## Fishing Pier

- County Park Road Launch

Lynn Portal Area

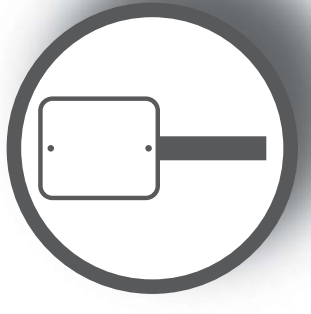
- +/- 100 Parking Spaces (Boat Trailer and Car Parking)
- Accessible Parking is accommodated
- Efficient access to boat ramp, playground, picnic shelters, and water's edge

- Consider providing shade for parking areas during peak use in summer months
- Where appropriate, implement sustainable stormwater management strategies to reduce runoff into Cross Creek Reservoir
- Provide paths for efficient and safe pedestrian circulation: Reduce vehicle and pedestrian conflicts
